Support for Comment #65

Jeff Slavick

FEC Codeword

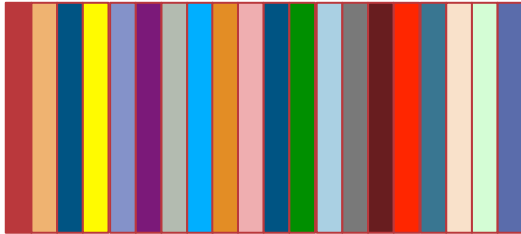
Each codeword composed of 20 257b TC blocks

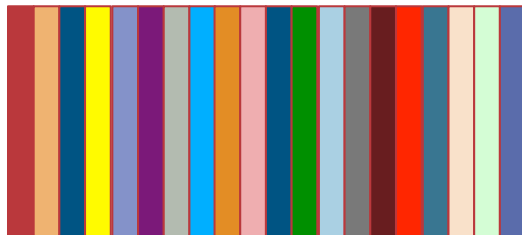
Normal FEC codeword

AM FEC codeword

When does error marking breakdown?

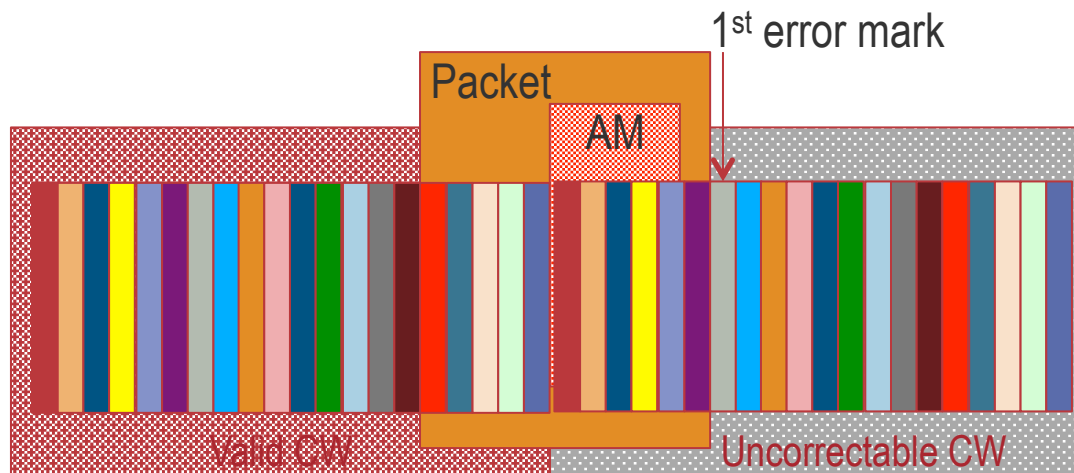
Valid normal codeword is followed by an uncorrectable AM codeword. Packet starts in the valid codeword and ends in the 1st TC block after the AM. First error mark of the uncorrectable AM codeword occurs on the 7th TC block. The 6th TC block contains packet TERM, so data in the 6th could be corrupted and allowed through.

- When error marking an uncorrected codeword the specification intends to mark all packets that contain data within the codeword as bad. When the codeword begins with Alignment markers the first set of data in the codeword is contained in the 6th transcoded block.
- Marking currently occurs on the 1,3,5,7,...etc transcoded blocks, so we skip the 6th. This allows for a some bad data to potentially not be marked.

- **Change:** In addition, it shall ensure `rx_coded_3<1:0>` corresponding to the last (20th) 257-bit block in the codeword is set to 11.
- **To:** In addition, it shall ensure `rx_coded_0<1:0>` corresponding to the 6th 257-bit block and `rx_coded_3<1:0>` corresponding to the last (20th) 257-bit block in the codeword is set to 11.
